Lower Thames Crossing

9.152 Responses to the Examining Authority's ExQ2 Appendix G – 11. Biodiversity (Part 1 of 2)

DATE: October 2023
DEADLINE: 6

Planning Inspectorate Scheme Ref: TR010032
Examination Document Ref: TR010032/EXAM/9.152

Page 2 of 14

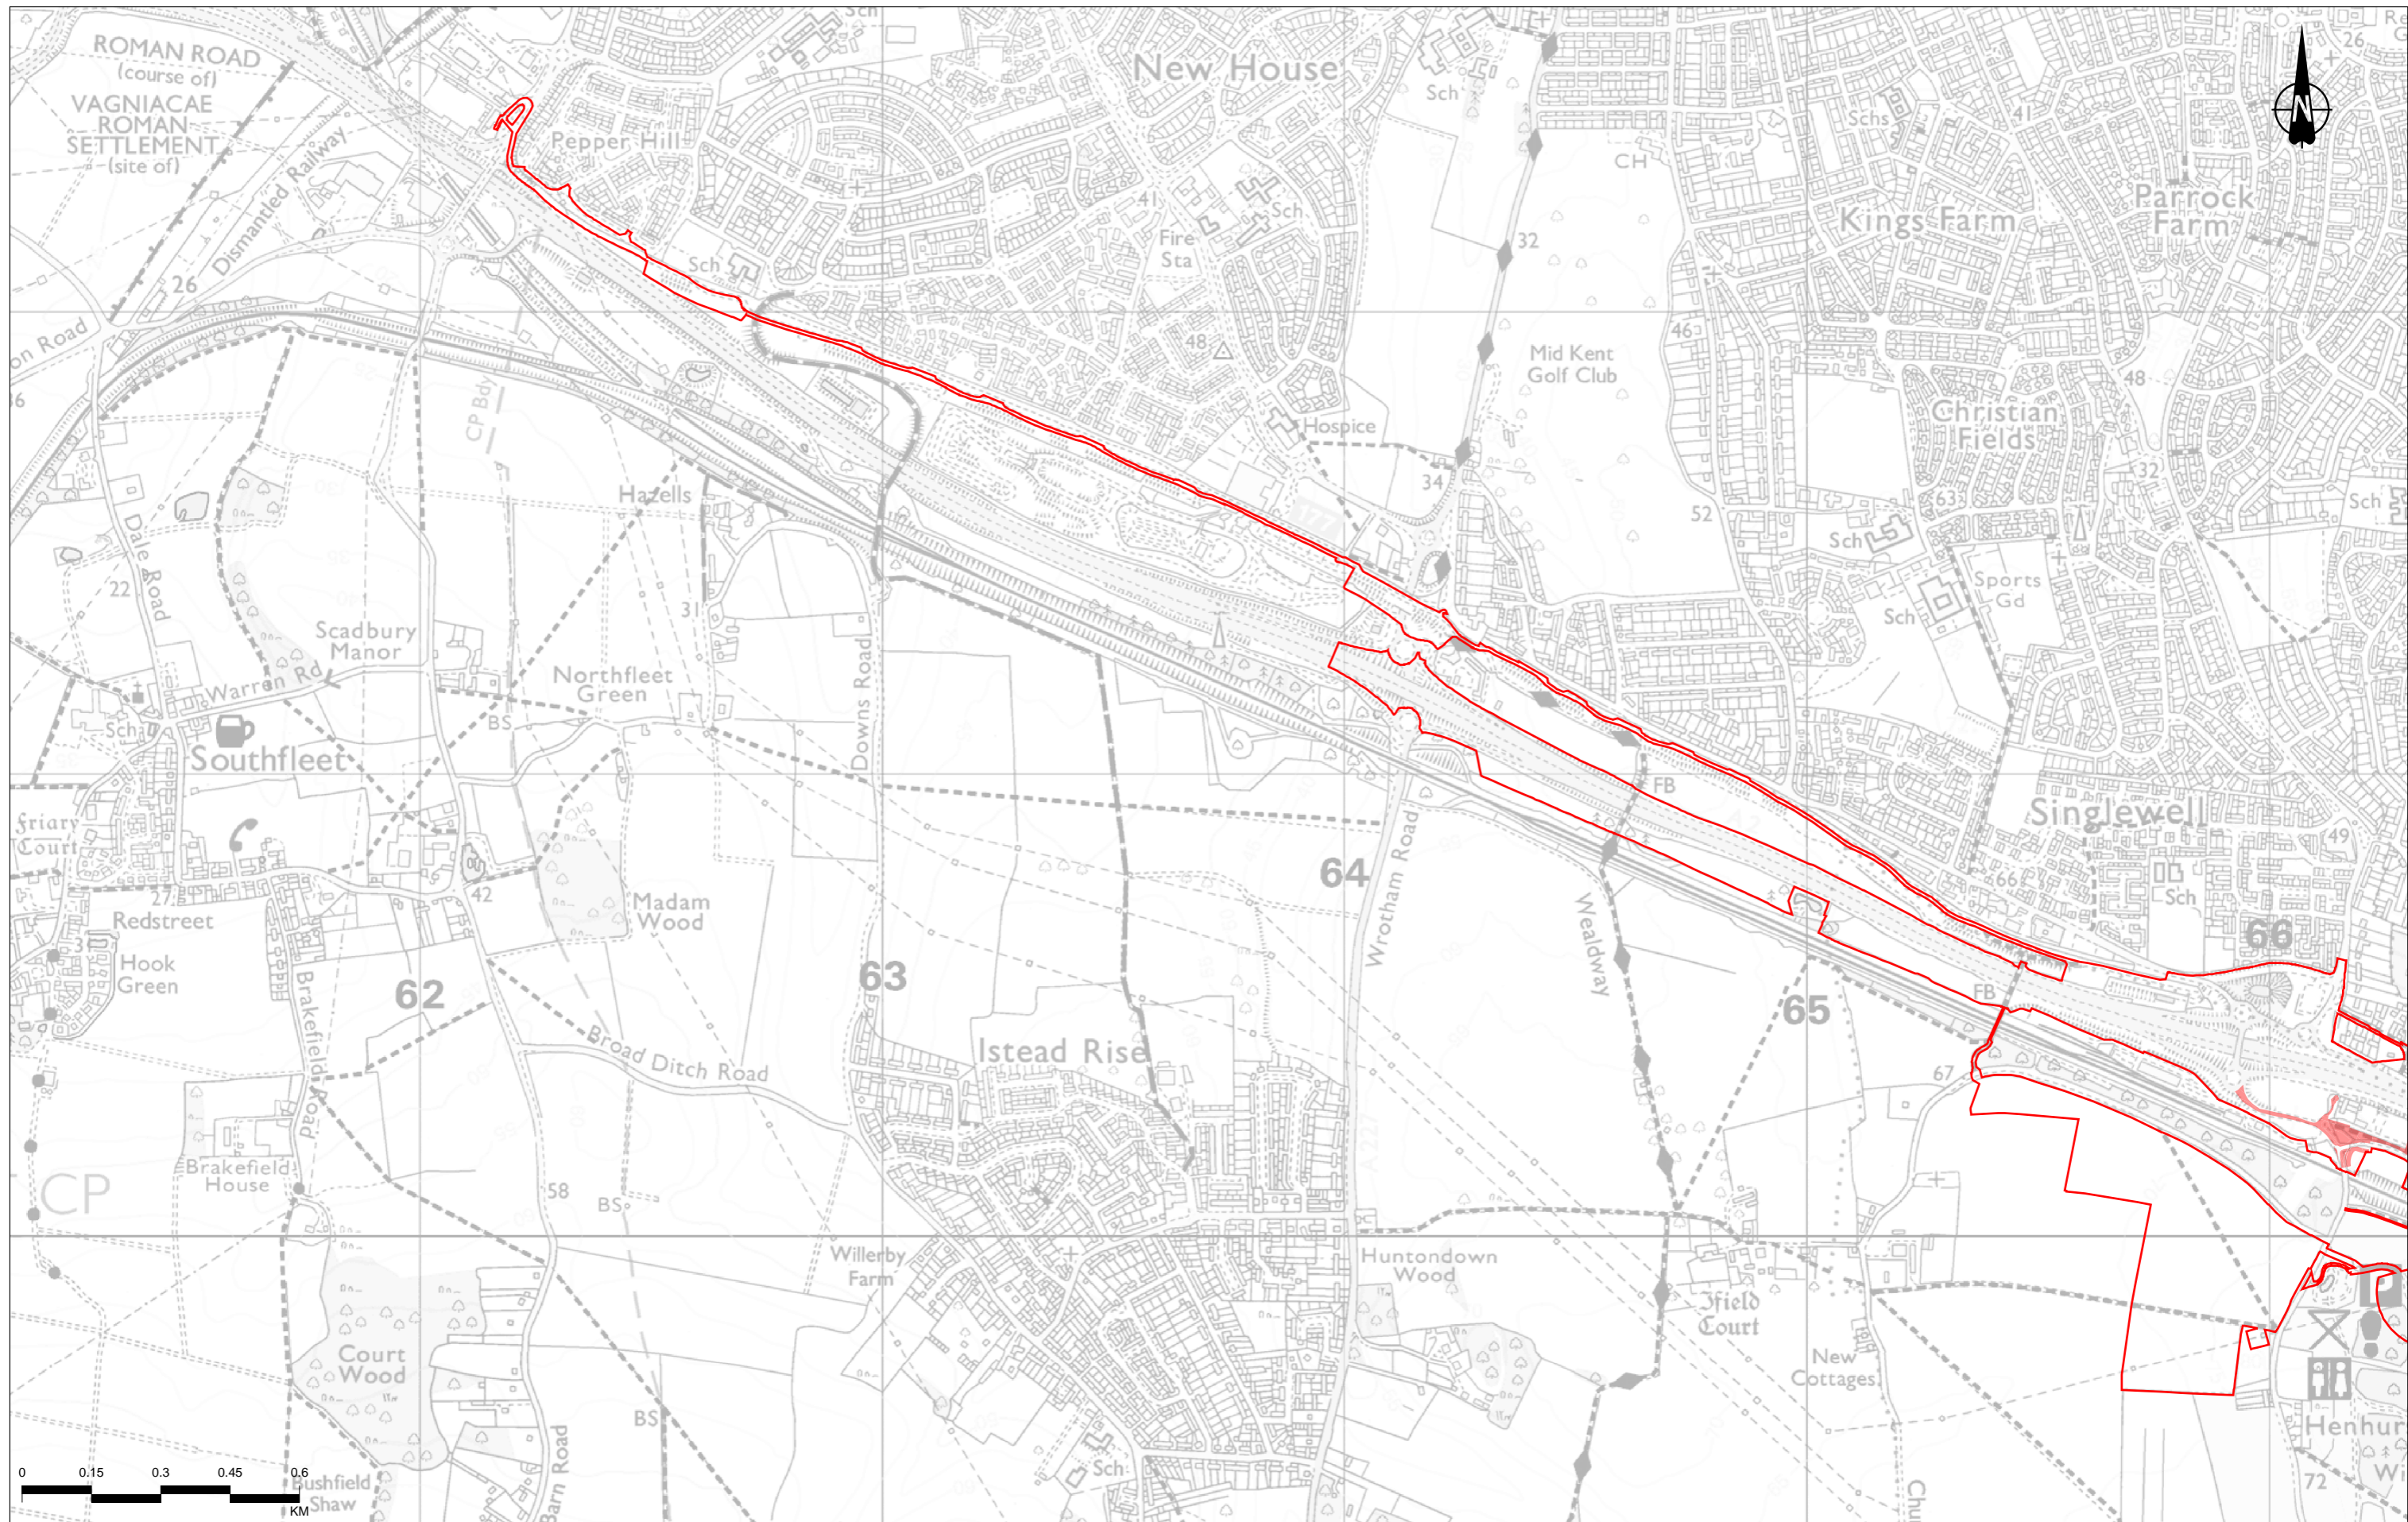
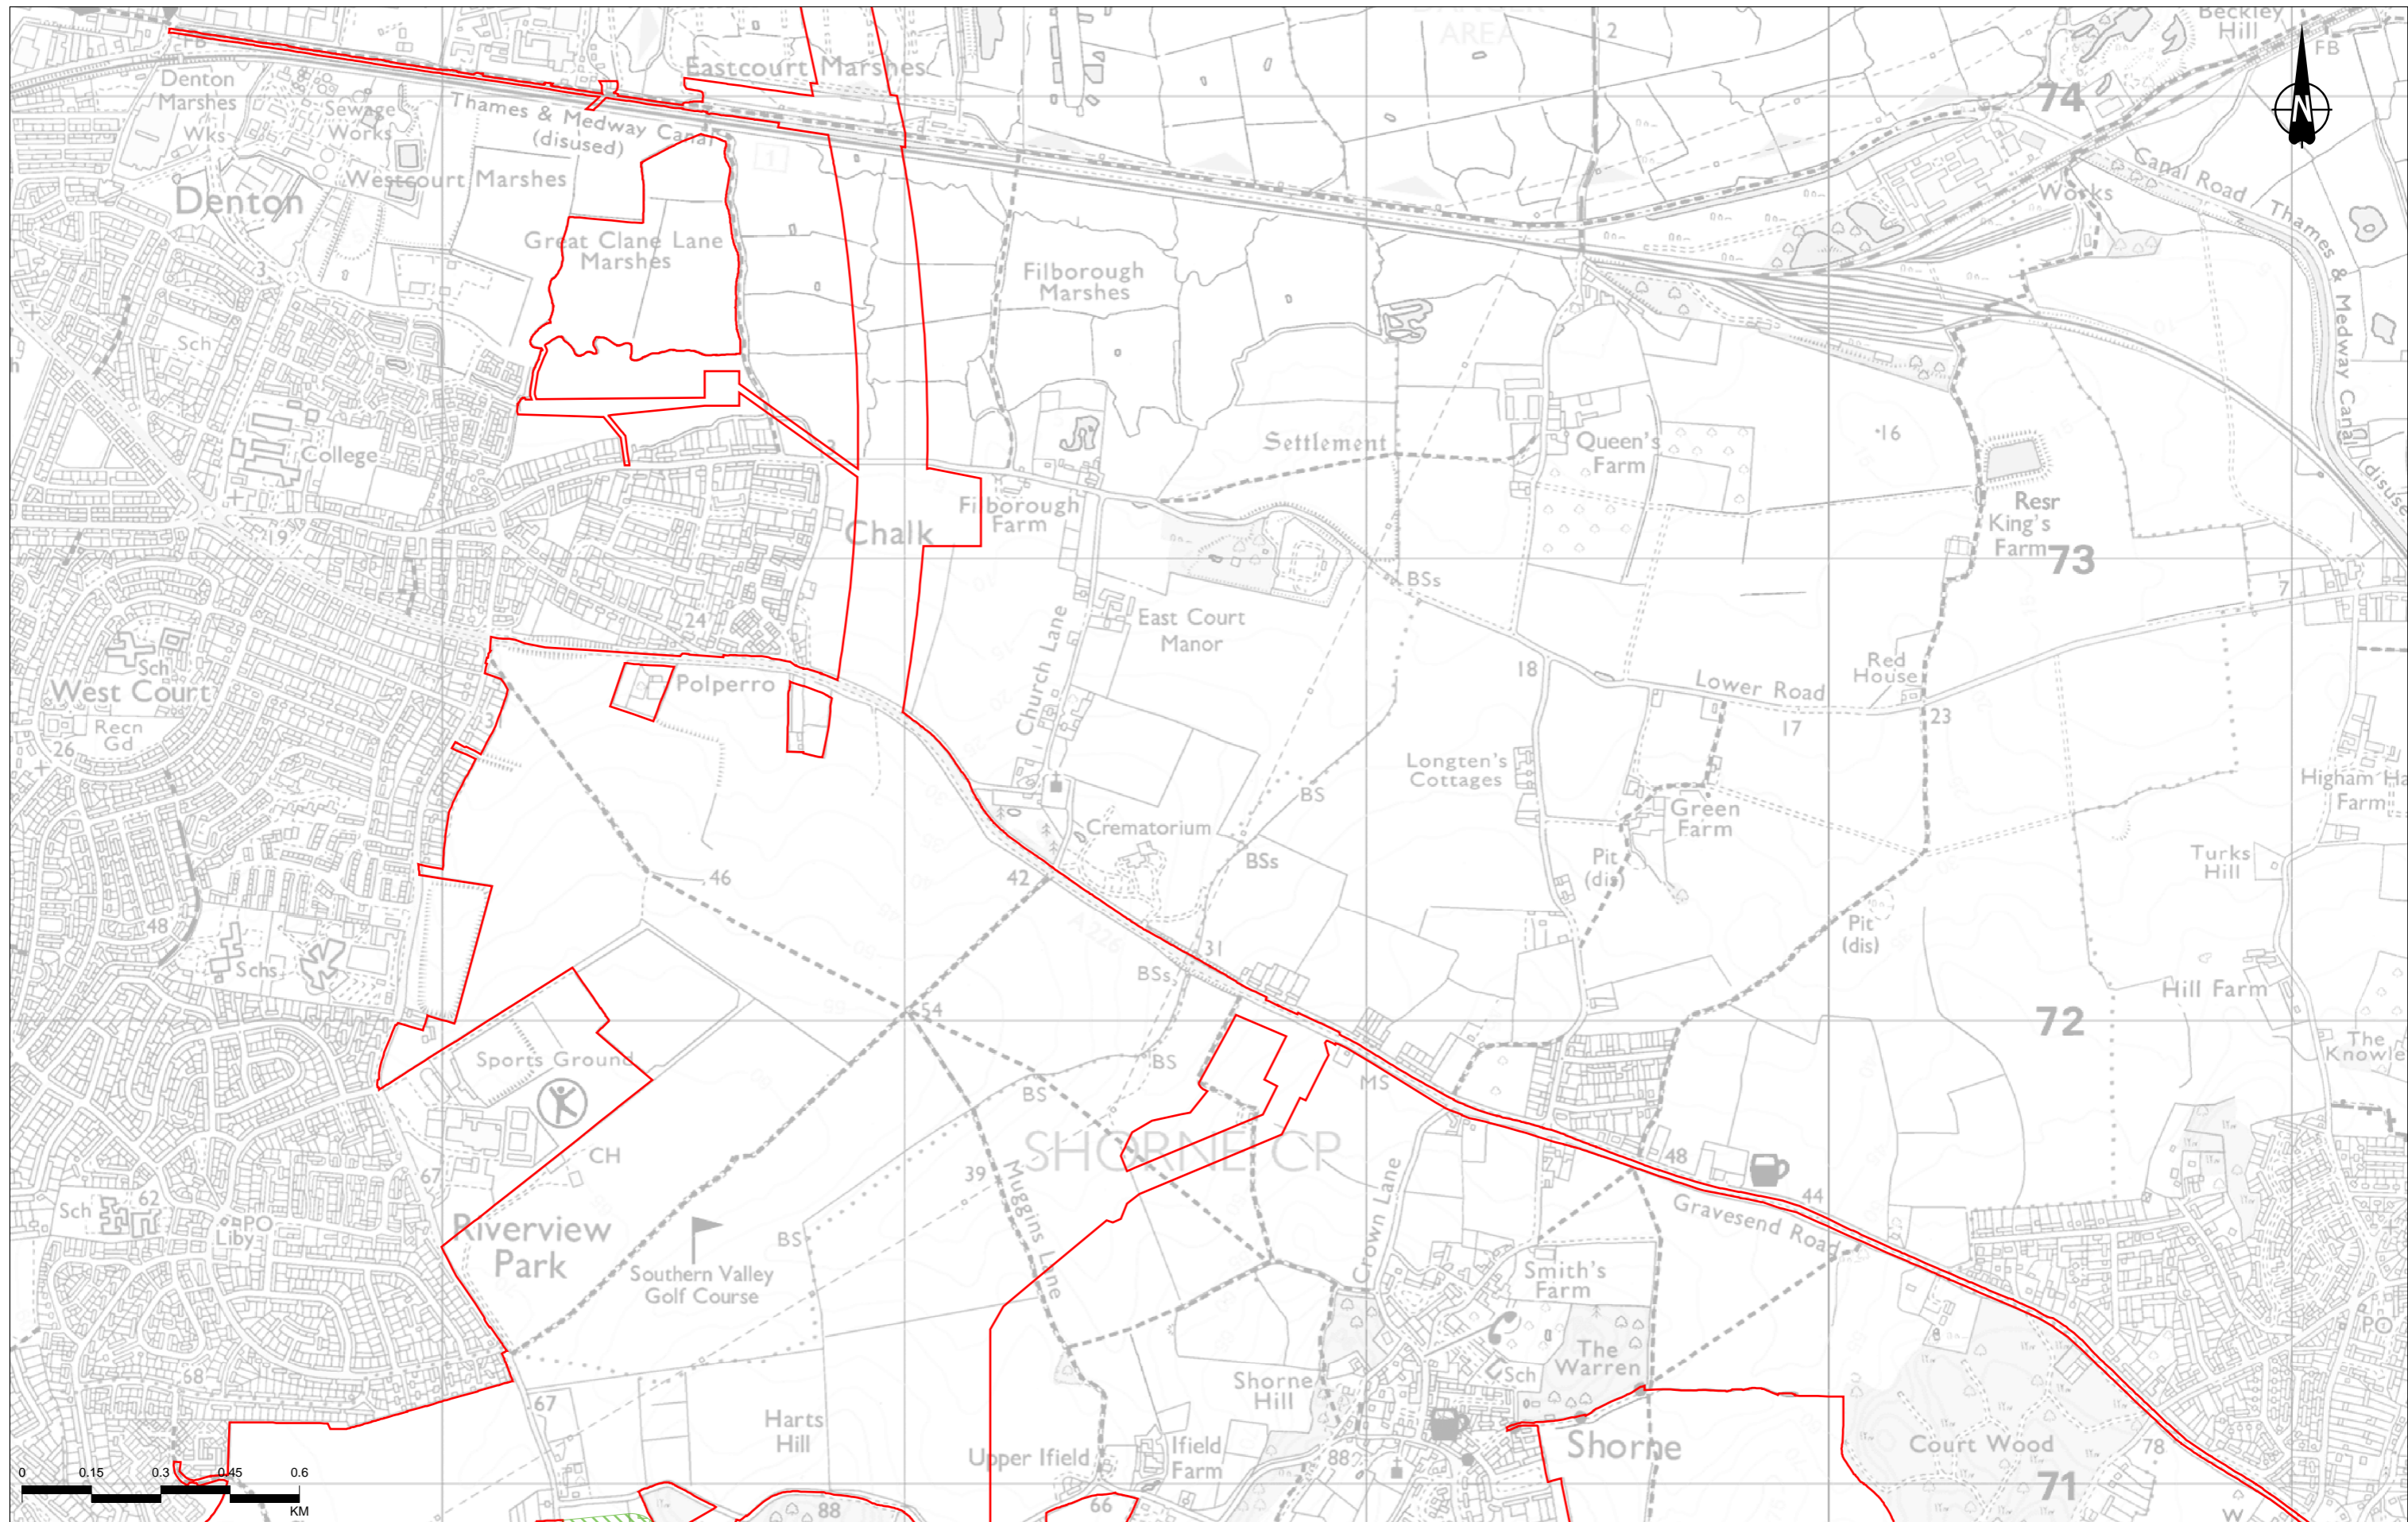
ExQ2_Q11.3.2	Applicant	<p>Offsetting</p> <p>The document reference 9.90 Mitigation Route Map [REP4-203] is noted, but the ExA would like to see a simple graphical representation / location plan to understand which area(s) of habitat are being created for particular impacts; such an approach will help provide clarity that the impacts are fully mitigated or compensated for. The detail provided in Tables 8.31 (south of the River Thames) and 8.35 (north of the River Thames) of Chapter 8 Terrestrial Biodiversity of the Environmental Statement [APP-146] are noted, but it continues to be difficult to track where the individual areas of habitat impacted are mitigated or compensated for on the ground within the submitted documents.</p> <p>Response:</p> <p>The Applicant has provided simple graphical representations which illustrate the location and extent of habitat creation proposals and the corresponding Project impacts for which they provide mitigation and compensation. These cover the following key habitat types:</p>

PINS ID	Question to:	Question / Response
		<ul style="list-style-type: none"> • Woodland (excluding designated woodland loss and compensation which is reported in ES – Figure 8.33: Ancient Woodland Impacts [APP-294]) • Open mosaic habitat • Grassland (excluding amenity and poor semi-improved grassland of low biodiversity value) • Hedgerows <p>These figures are provided in the Figures Annex to this document. We are also working to produce a similar map showing wetland habitats which, due to the range of wetland habitats involved, will be submitted at Deadline 7.</p>
ExQ2_Q11.3.3	Applicant	<p>Biodiversity Net Gain (BNG)</p> <p>In a similar manner to ExQ2 Q11.3.2 of this set of questions, the ExA requests the Applicant provide a graphical representation / location plan in addition to that detailed above showing all areas of environmental improvement included in the BNG metric.</p> <p>Response:</p> <p>The Applicant’s BNG Metric assessment [APP-417] includes all areas of <i>direct habitat loss and creation</i> within the Order Limits, with the following exceptions:</p> <ul style="list-style-type: none"> • Ancient woodland habitat lost (6.87ha) as a result of the Project is excluded from the baseline assessment. • Wood-pasture parkland habitat lost (0.07ha) as a result of the Project is excluded from the baseline assessment. • Bespoke compensation for ancient woodland loss (81ha) is excluded from the post-intervention assessment. • Nitrogen deposition compensation areas (246ha) are excluded from both the baseline and post-intervention parts of the assessment. <p>Areas of temporary land-take within the Order Limits are included in the BNG Metric assessment. For these areas, there is an assumption in the Metric assessment that the baseline habitat is lost and then re-instated post-construction to the same habitat type and condition as in the baseline.</p> <p>These explanatory notes support the Applicant’s submission of graphical representations / location plans which the Applicant commits to issuing by Deadline 7, so that it is clear which features on the plans are included in the BNG Metric.</p>
